UNITED STATES PATENT AND TRADEMARK OFFICE

APPLICATION NO.	FILING DATE	FIRST NAMED INVENTOR	ATTORNEY DOCKET NO.	CONFIRMATION NO.
10/669,899	09/24/2003	Mitsuhiko Sato	CANO:087	2245

Office Action Summary

DETAILED ACTION

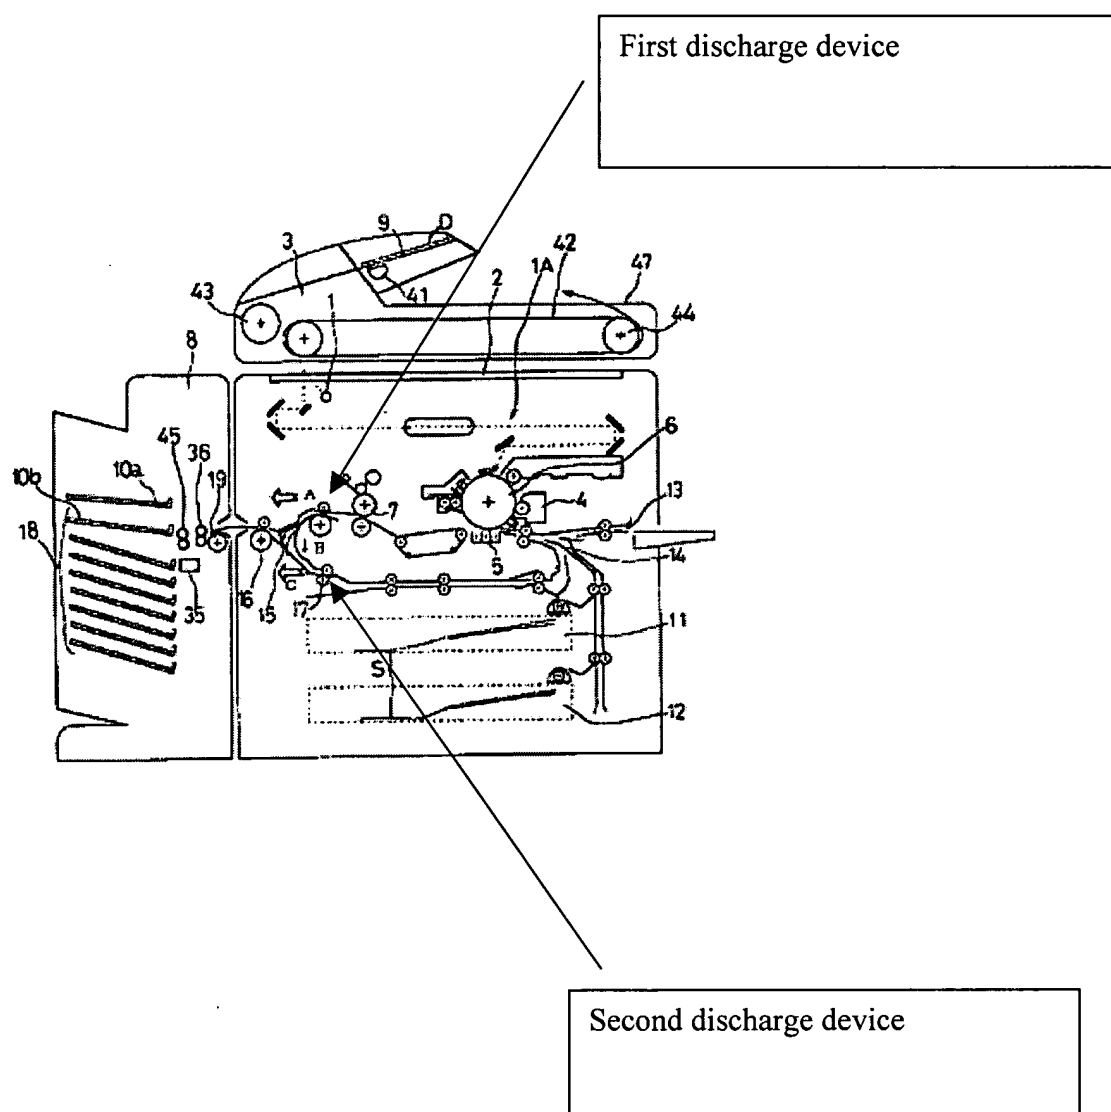
6. The applicant states that the drawings illustrate a first sheet feed device that feeds each of the tab sheets of the predetermined tab sheet bundle to an image transfer position via a first conveying path with the tab sheet being inverted because the drawings illustrate that that all sheets fed to a conveying path that inverts the sheets via the switching flapper and associated rollers described on page 31 of the specification. In response, the examiner notes that the conveying path that inverts the sheets is after the image transfer position. Therefore the path described on page 31 of the specification cannot be the claimed conveying path because it does not feed the sheets to an image transfer position. Rather, it feeds sheets from an image transfer position.

7. In rebutting the rejection under 35 U.S.C. 112 1st paragraph, the applicant states that pages 28 and 31 demonstrate a conveying path that inverts sheets. The examiner agrees that pages 28 and 31 disclose a conveying path that inverts sheets. However, the conveying path that inverts the sheets is after the image transfer position. The claims recite that the conveying path that inverts the sheets is before the image transfer position.
